T.I. no.: 2016 - 94 Updated: -	Topic: Software update 3.20 and 3.30
---	---

Date: 21/12/2016	Priority	Need for action
Affected machines: JDE Barista ONE	High	As soon as possible
From serial number: See below	X Medium	X On next visit to the machine
As of date: -	Low	FYI only

NEW FUNCTIONS AND IMPROVEMENTS IN 3.20

"Out of order" screen

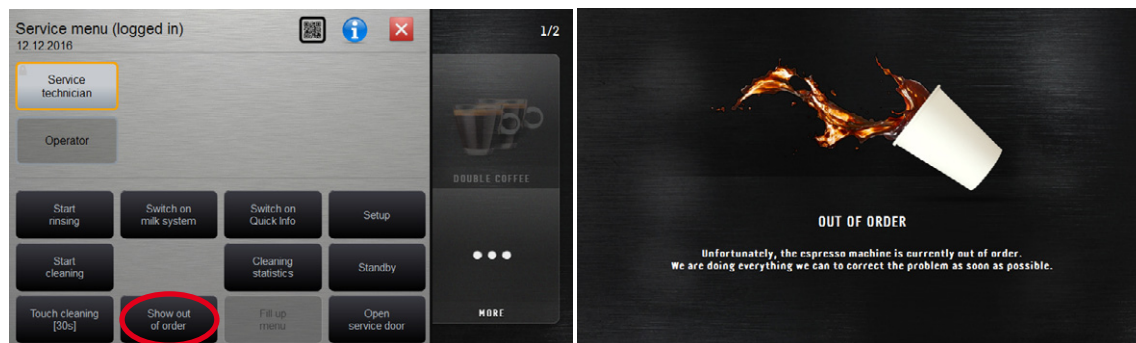
In version 3.20, the "Out of order" screen can be displayed via the Service menu and the "Show out of order" button. This screen also appears when a fatal error occurs (e.g. overcurrent).

MDB interface communication stops as soon as the "Out of order" screen is active.

Extended selection options of the waste water system during commissioning.

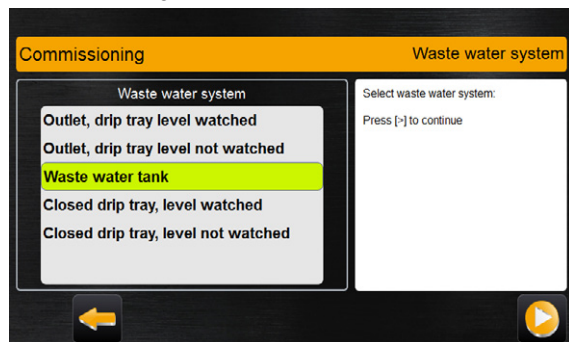
The selection options for setting the waste water system have been extended to correctly define level monitoring during commissioning.

- Outlet, drip tray level monitored
- Outlet, drip tray level not monitored
- Waste water tank
- Closed drip tray, level monitored
- Closed drip tray, level not monitored
